NEW MEXICO OIL CONSERVATION DIVISION
- Engineering Bureau -
1220 South St. Francis Drive, Santa Fe, NM 87505

APPLICATION FOR AUTHORIZATION TO INJECT

Application for Authorization to Inject
Lusk Deep Unit 2 SWD
Unit O, Section 18-T19S-R32E

From: Brian Collins [engineering@marbob.com]
Sent: Friday, September 01, 2006 9:29 AM
To: Jones, William V., EMNRD
Subject: Re: SWD Application: Lusk Deep Unit #2 API No. 30-025-00900 Strawn Oil Zone Injection Proposal

Lusk Deep Unit 2
 660' FSL, 1980' FEL
 Sec. 18-19s-32e
 Lea Co., NM

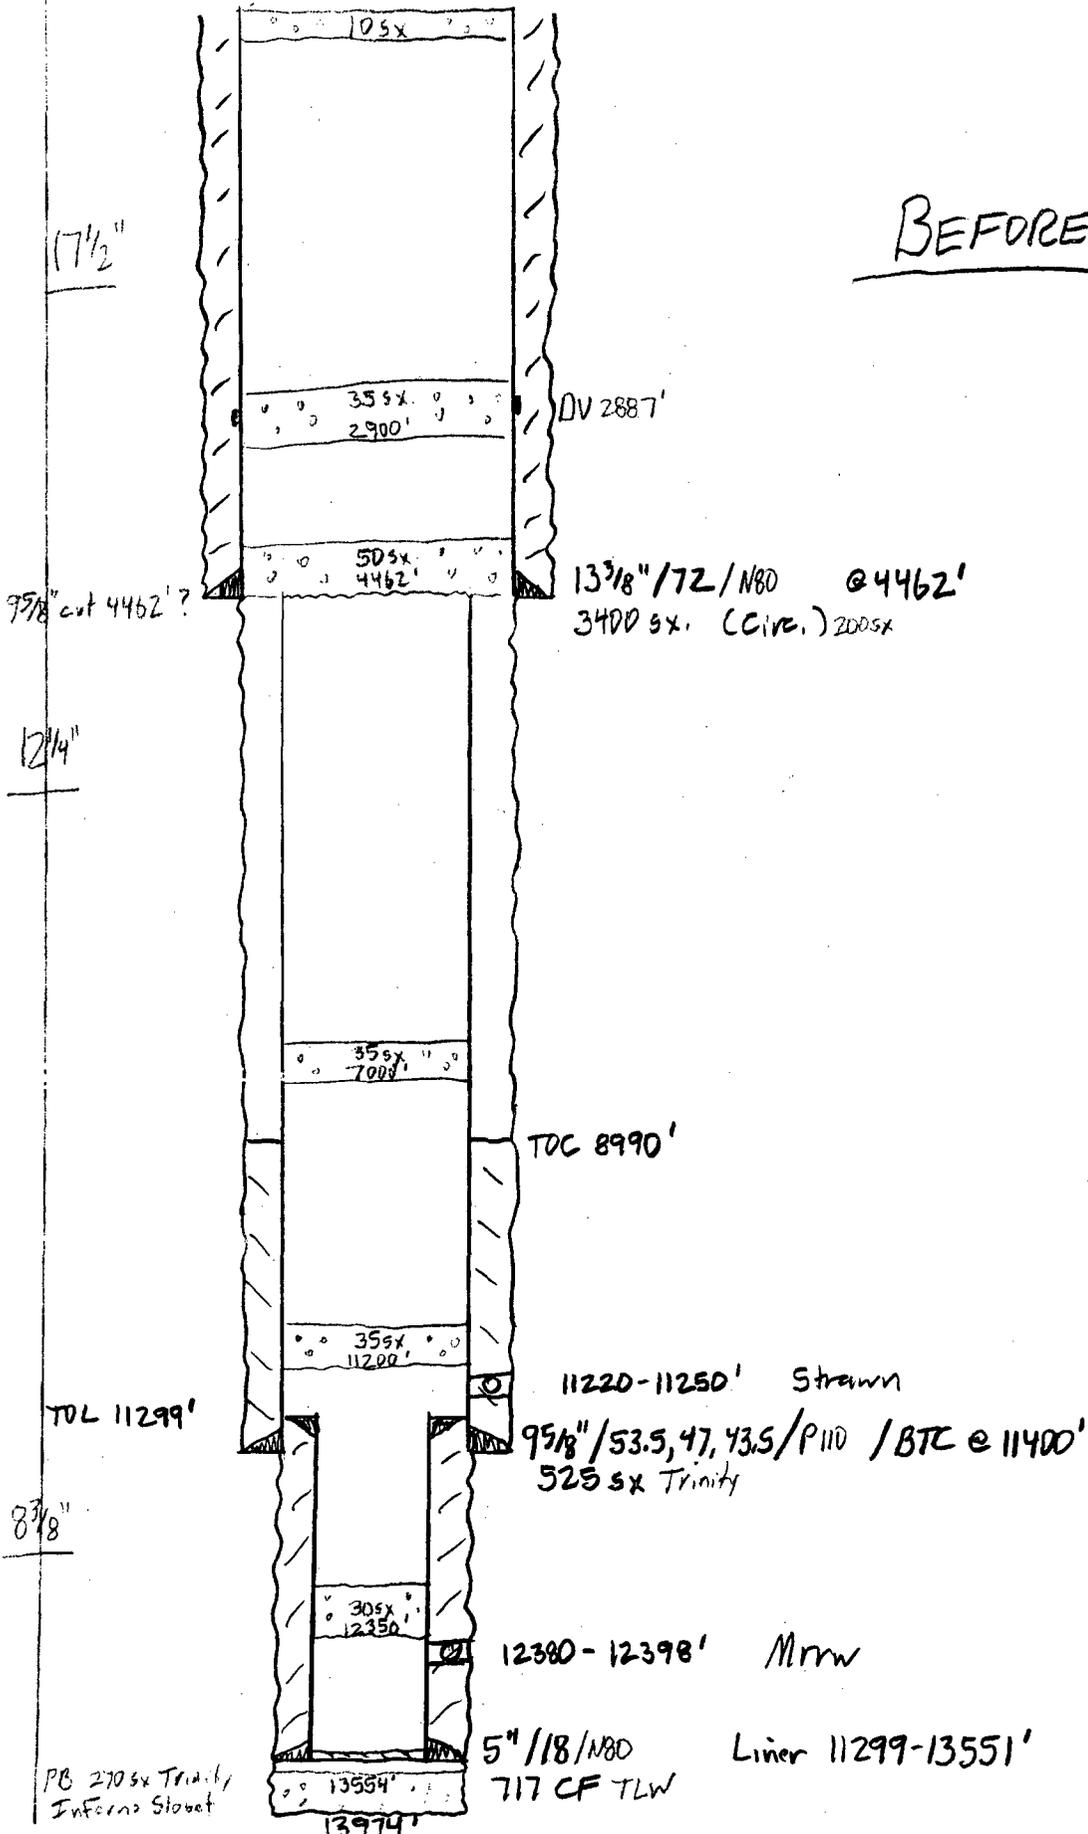
- 5) I understand that this well and two other nearby wells are not/ will not be cemented over an interval in the Delaware. Are you not worried about future corrosion to your new 5-1/2 inch P-110 casing above 9000 feet? Does the LDU A-13 or the LDU A-16 have any bradenhead flows or constant pressure?

- 5) Corrosion: Corrosion in the Bone Spring and Delaware doesn't seem to be a problem in this area, at least in our wells. The Lusk 2 has 9-5/8" casing in place, but not cemented, from 9000' to 4462'. This is a barrier to any potential corrosion of the 5-1/2" casing. The Lusk Deep 13 and 16 don't have any pressure or flows from the bradenhead or other annuli.
